Vermont Agency of Transportation
RECEIVED
 ON: January 28, 2014
 and Checked for
CONFORMANCE
 BY: Jennifer Fitch DATE: 02/04/2014

J.P. CARRARA & SONS INC. Precast & Prestress Manufacturer 300 ONE DR., BRATTLESBURY, VERMONT 05752 Phone: (802) 288-4204 Fax: (802) 288-9110	T. BUCK CONSTRUCTION CONTRACTOR AUBURN, MAINE	
	STATE OF VERMONT AGENCY OF TRANSPORTATION COUNTY OF ADDISON	DATE: OCT. 9, 2013 SCALE: NOTED
	TOWN OF MIDDLEBURY ROUTE NO. VT 129, EAST MIDDLEBURY GORGE BRIDGE NO. 13 PROJECT NO. 13 0174(8)	CHD: OFM: T.D. JOB NO: 23-611-013 DWG. NO: F2

J.P. CARRARA & SONS INC. Precast & Prestress Manufacturer 101 W. 10th St., Burlington, Vermont 05401 Phone: (802) 249-4201 Fax: (802) 249-4202	T. BUCK CONSTRUCTION CONTRACTOR AUBURN, MAINE
STATE OF VERMONT AGENCY OF TRANSPORTATION COUNTY OF ADDISON	DATE: OCT. 4, 2015 SCALE: NOTED
TOWN OF MIDDLEBURY ROUTE NO. VT 125, EAST MIDDLEBURY GORGE BRIDGE NO. 13 PROJECT NO.: RS 014(b)	CHKD: DFM: T.D. JOB NO: 2341-013
ABUTMENT 1 & WINGWALL SECTIONS	DRG. NO: F3

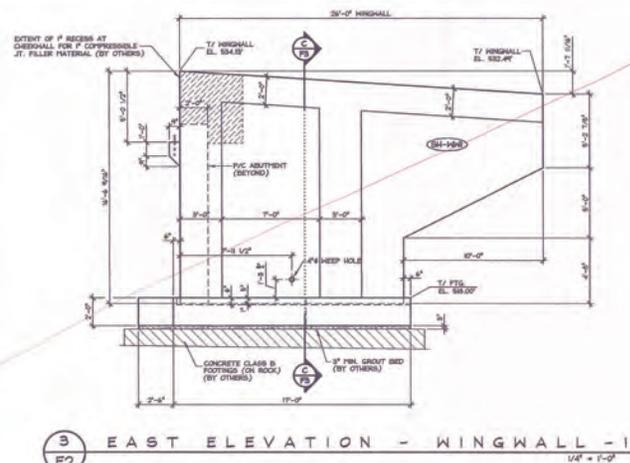
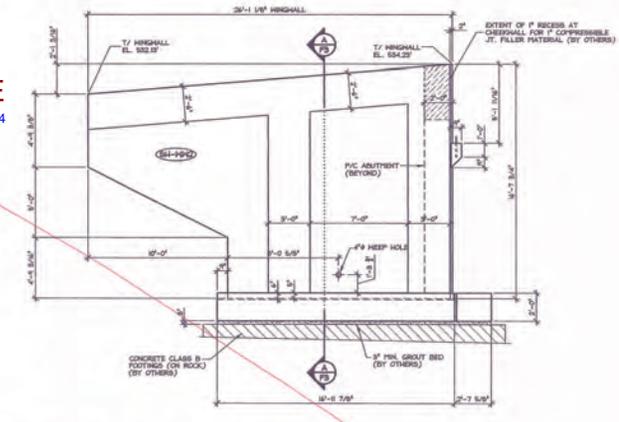
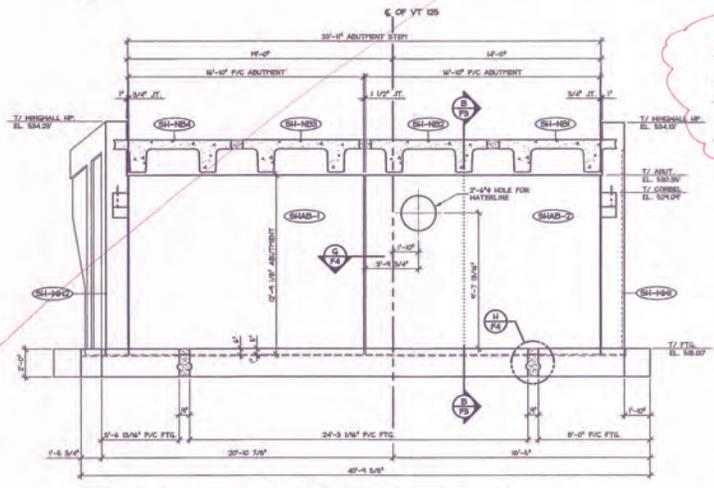
SHEET NOT
 REVIEWED.
 See IPC TRANSMITTAL
 # 12 FOR REVISED
 SHEET

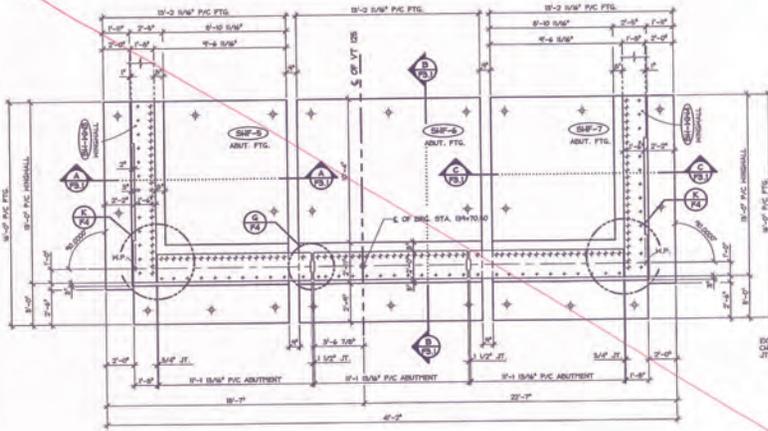
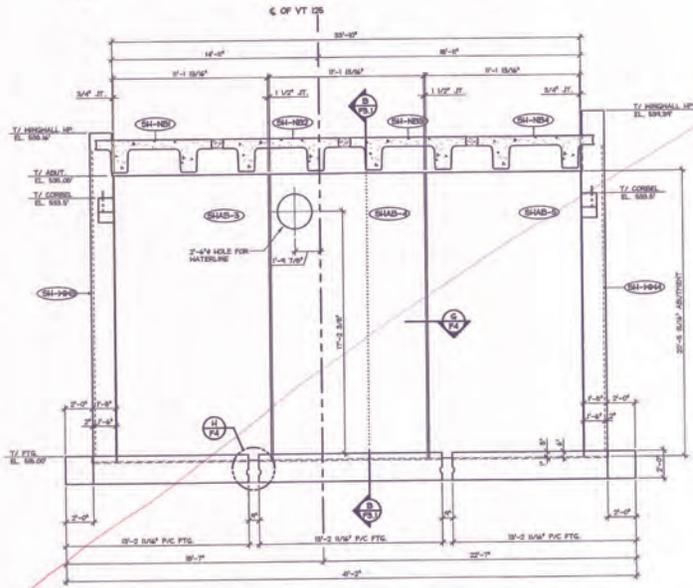
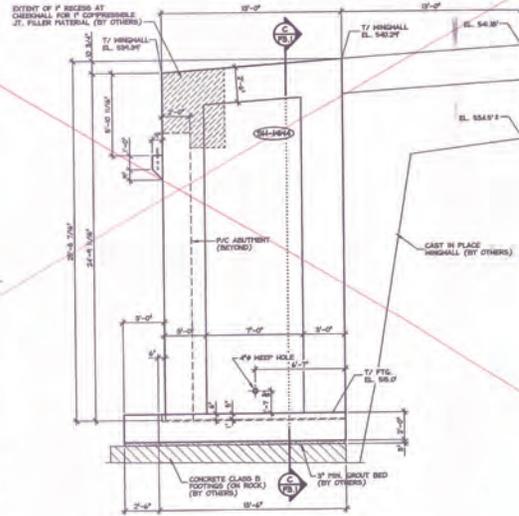
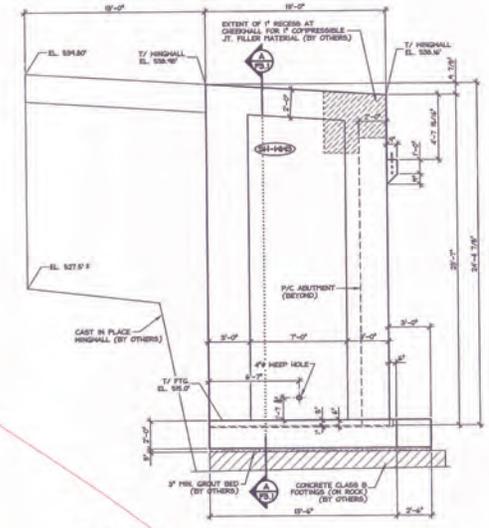
SHEET NOT REVIEWED
SEE JPC
TRANSMITTAL # 12
FOR REVISED SHEET.

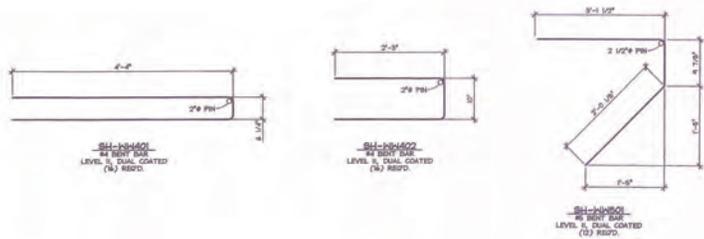
SHEET NOT REVIEWED SEE JPC TRANSMITTAL #12 FOR REVISED SHEET.
